INSTRUCTION TO SERVICE

ITS: 5184	
SECTION:	219 Engine and Transmission
WRITTEN BY:	Mike Pearson
SUBJECT:	Reroute the DEF pressure hose assembly

Figure 1: Existing DEF & Coolant Hose Configuration

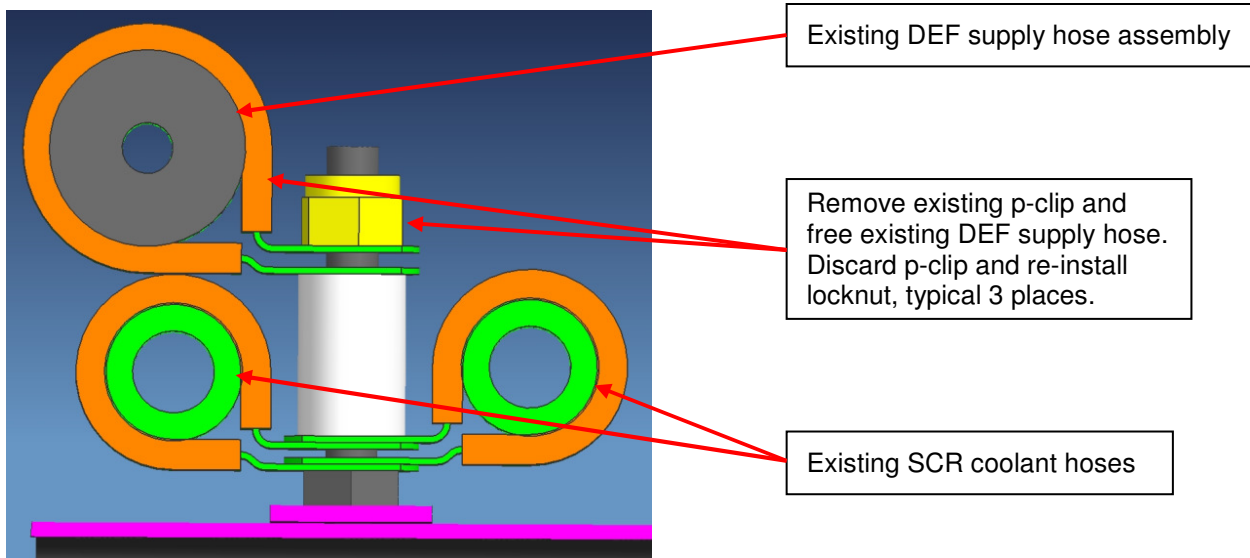
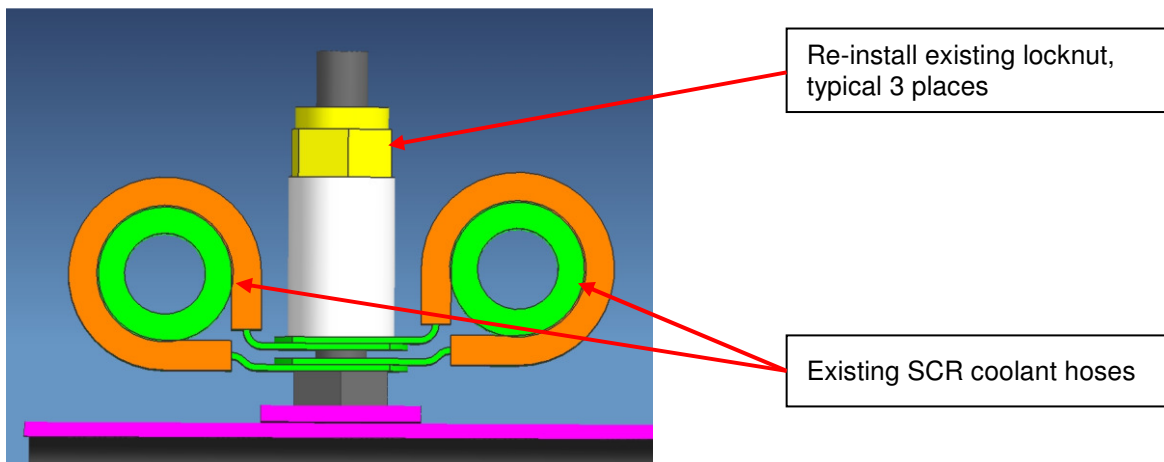
1. Turn the main battery disconnect switch to the “OFF” position.
2. If hot, allow sufficient time for the SCR and surrounding area to cool.
3. Locate and remove the SCR grille frame assembly and set aside for reuse later in this install.
4. Remove the locknuts that hold the DEF supply and coolant hose p-clips to the compartment floor, typical 3 places. See Figure 1.

5. Remove and discard the p-clips that are securing the DEF supply hose assembly only to the bottom of the SCR compartment and re-install the locknuts removed in previous step, typical in 3 places. See Figure 2.

Figure 3: DEF Supply Hose Routing

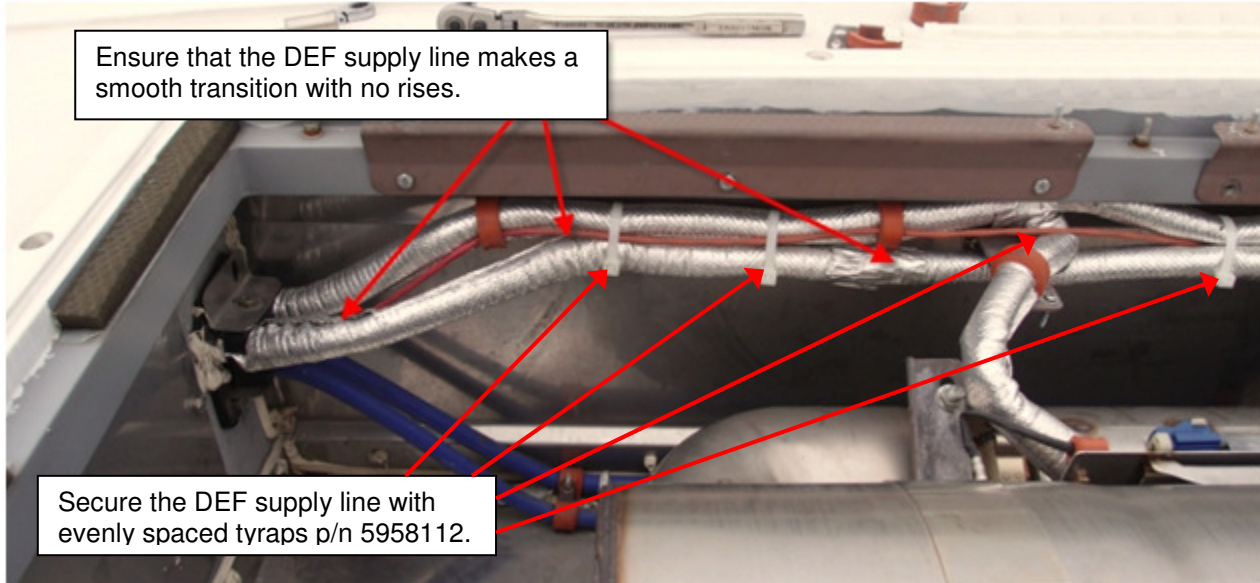
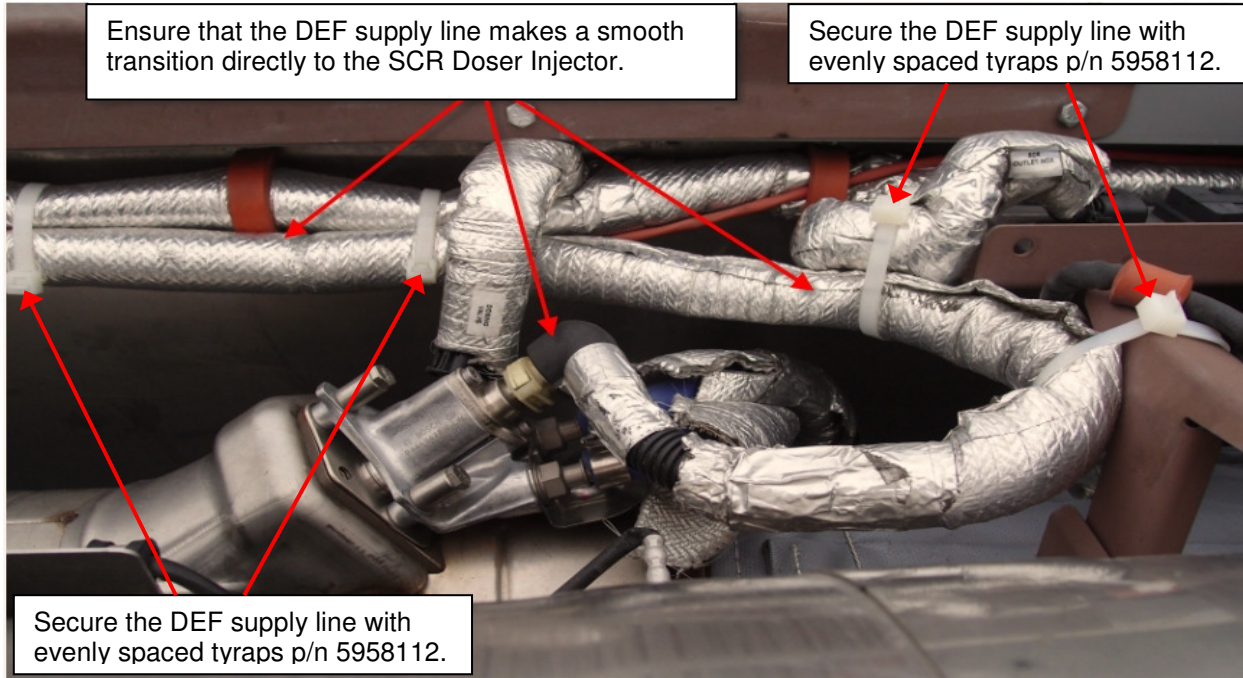
6. Examine the DEF supply hose assembly insulated wrap for any tears or gaps and repair as needed.
7. Secure the existing DEF supply hose assembly to the existing SCR harness bundle using evenly spaced tyrap p/n 5958112. Ensure the DEF supply hose makes a smooth transition with no rises. See Figure 3 & 4.
